AGENDA

The Columbia Historic Zoning Commission will meet on Thursday, May 12th, 2022 at 4:00 p.m. in the Council Chambers on the basement level of City Hall, 700 N. Garden Street to consider the following:

CITY OF COLUMBIA TENNESSEE
 HISTORIC ZONING COMMISSION
 STAFF REPORT

CA 22-0059

Double Sided Sign

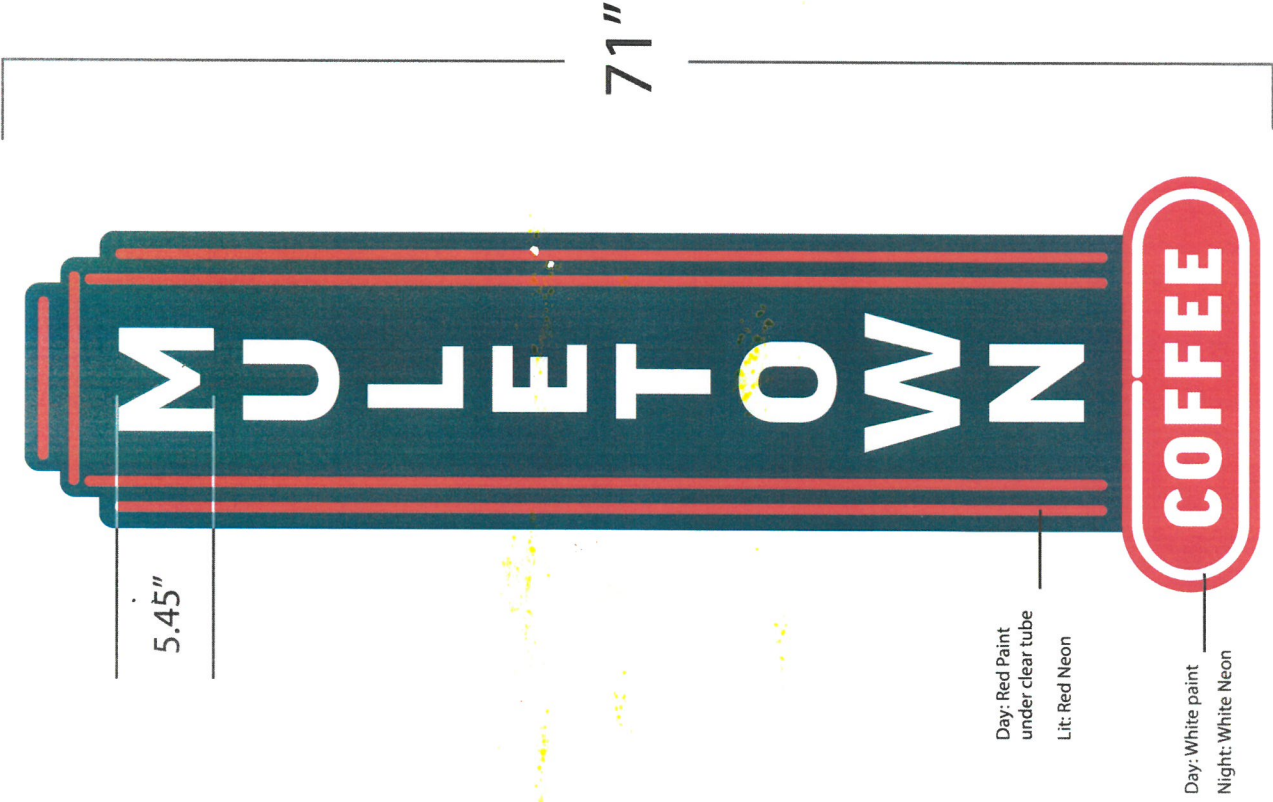
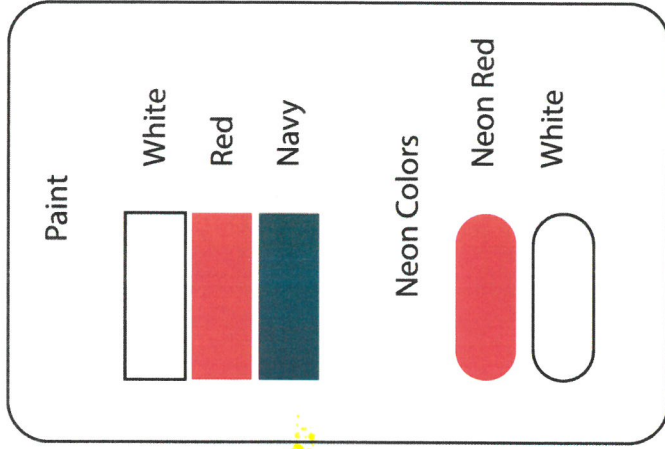
- The proposed signage will be mounted on this portion of the building and may obstruct a character-defining feature of the building. However, the building's ground floor façade has been repeatedly modified throughout its history as different businesses have utilized the storefronts. Some buildings in the District are distinguished by projecting signs. A projecting sign in keeping with the historic character of the District may compliment the character-defining elements of the building and itself become a distinguishing feature over time.

EXISTING VIEW FROM SOUTH GARDEN ST. (2013)

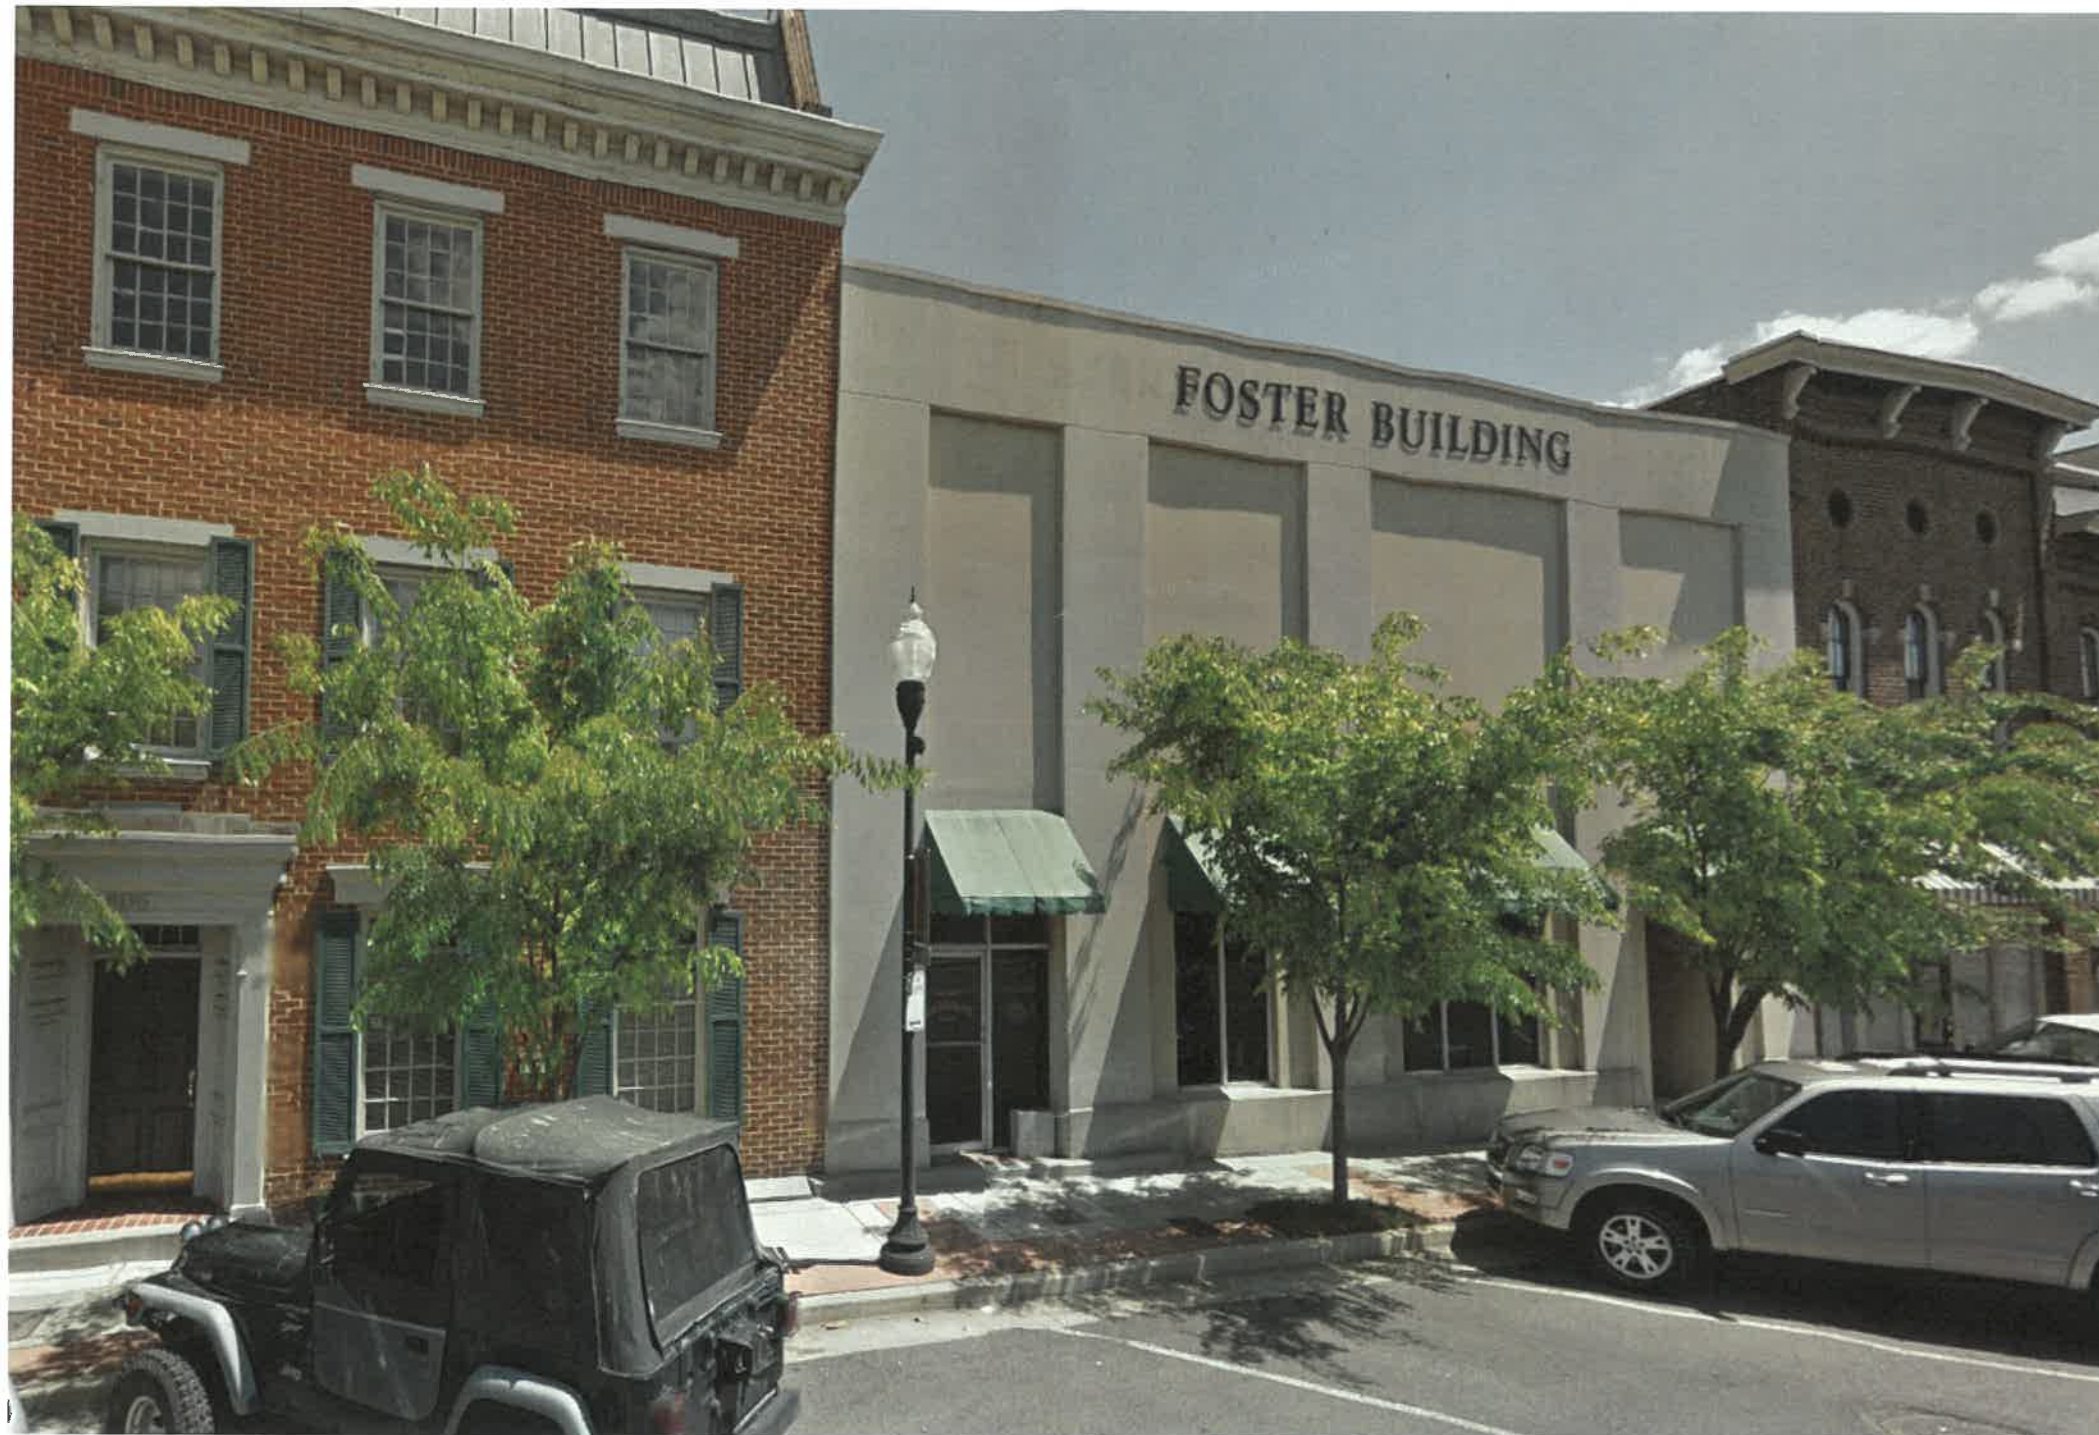
Item 1 Staff Comment: Placement of aluminum clad wood windows in former window openings including fiber cement panels and window trim.

In addition, this proposal comprises of the refinishing of the EIFS cladding and the restoration of former window openings on the upper faced with aluminum wood clad windows. The design of the proposed windows closely mimics an historic precedent with muntins in a crossbar pattern. Lower level windows contain the same pattern with materials and design with a cementous pattern trim design between the lower and upper story windows. A refinished storefront style door with upper transoms replace an existing storefront door. It would be required per the guidelines that this door be of a wood or fiberglass/composite material in lieu of a storefront style door.

Item 2 Staff Comment:

This request includes a significant modification from an EIFS cladding and single storefront door to be replaced with a full storefront window design and doorway. Historic photographic evidence indicates that this was a later addition to the building that was once a former alleyway.
